World Forum for Harmonization of Vehicle Regulations

Working Party on Noise and Tyres

Tyres: UN Regulation No. 106 (Tyres for agricultural vehicles and their trailers)

Proposal for amendments to UN Regulation No. 106

"Part C: Implement tyres

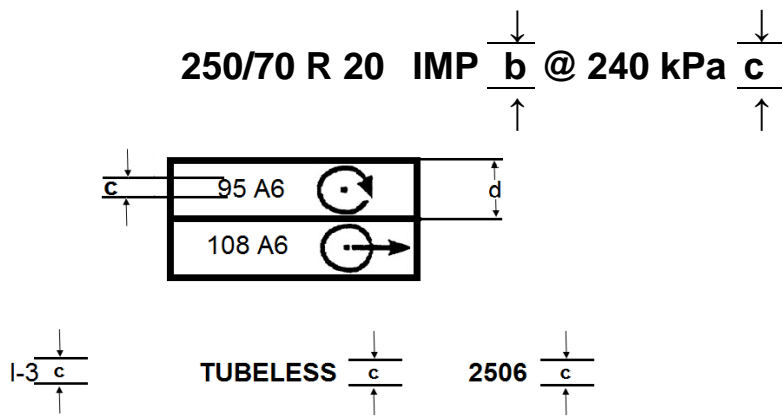
Annex 3, Part C, amend to read:

- (a) The **tyre** size designation, comprising **the prefix (if any)**, the nominal section width, the nominal aspect ratio, the type-of-structure symbol (where applicable), the nominal rim diameter and optionally the letters 'IMP' must be grouped as shown in the ~~above example~~**examples**:
250/70 R 20 IMP, **VF 650/55 R 26.5 IMP**;

- (a) Having a nominal section width of 250;
- (b) Having a nominal aspect ratio of 70;
- (c) Of radial-ply structure (R);
- (d) Having a nominal rim diameter of 508 mm, for which the code is 20;

- (e) Designed primarily for the equipment of implements, agricultural machinery or agricultural trailers (IMP);
- (f) Having load capacities of 690 kg corresponding to the load capacity index 95 shown in Annex 4 when used on driven axles (traction application), as identified by the appropriate symbol;

- (g) Having load capacities of 1,000 kg when used on non-driven axles (trailer application) corresponding to the load capacity index 108 shown in Annex 4, as identified by the appropriate symbol;

- (h) Both applications being classified in the nominal speed category **symbol A6** (reference speed 30 km/h);
- (i) For fitting without an inner tube "tubeless";

Tyre classification code

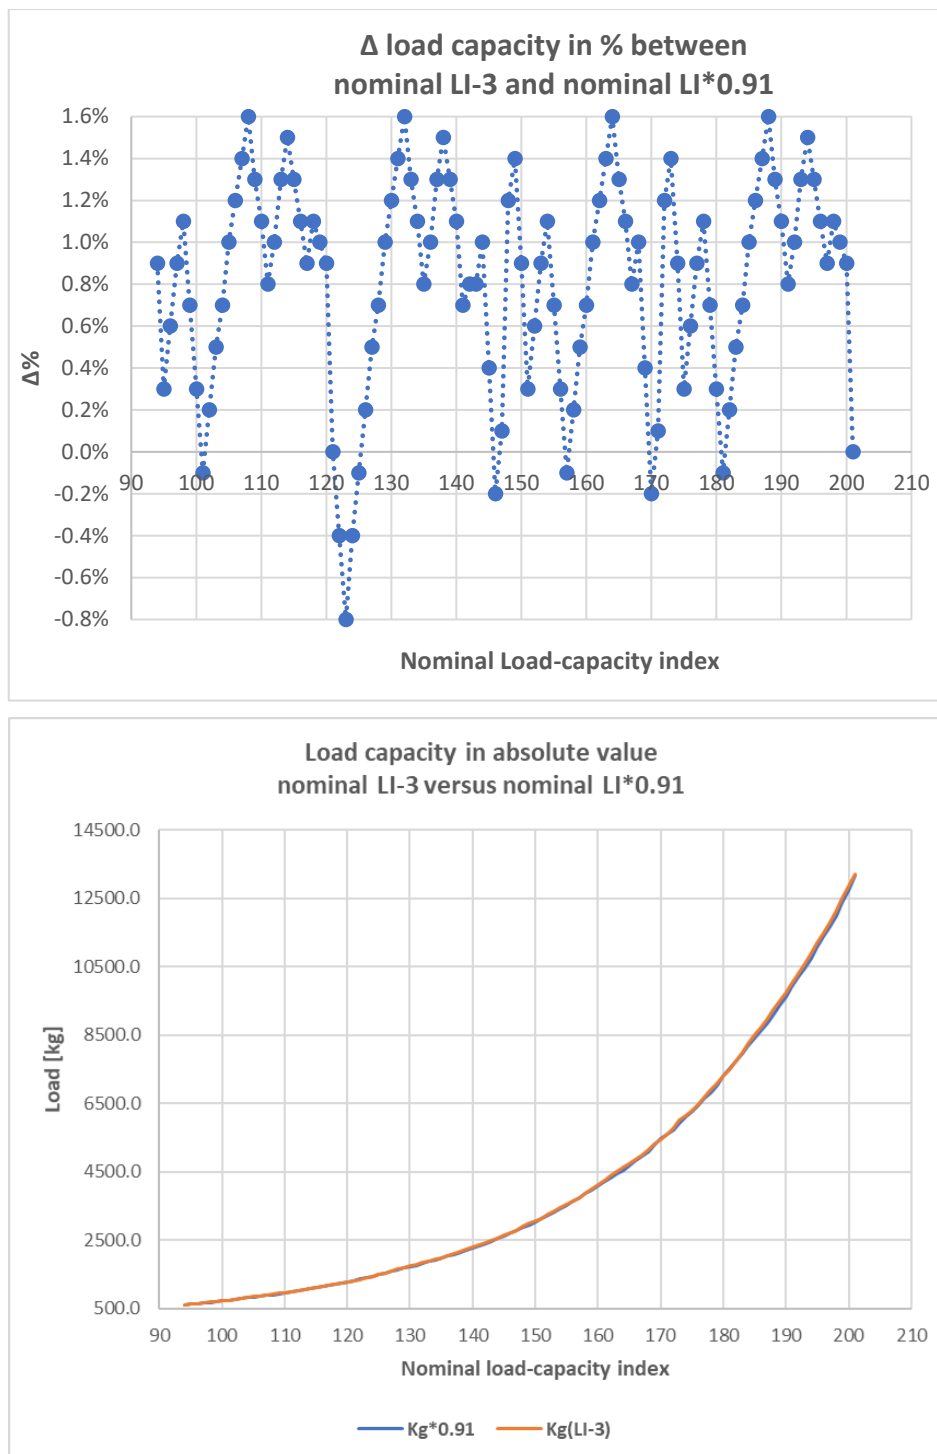
Annex 10, amend to read:

9. It is proposed to introduce the classification code “F-2M” currently standardized by tyre industry and used as an alternative to the marking F-2 in case of agricultural tyre with multiple rib tread.

Classification code	Nomenclature
F-1	Agricultural tractor steering wheel tyres: single rib tread
F-2 or F-2M	Agricultural tractor steering wheel tyres: multiple rib tread
F-3	Steering wheel tyres: industrial service (construction application)
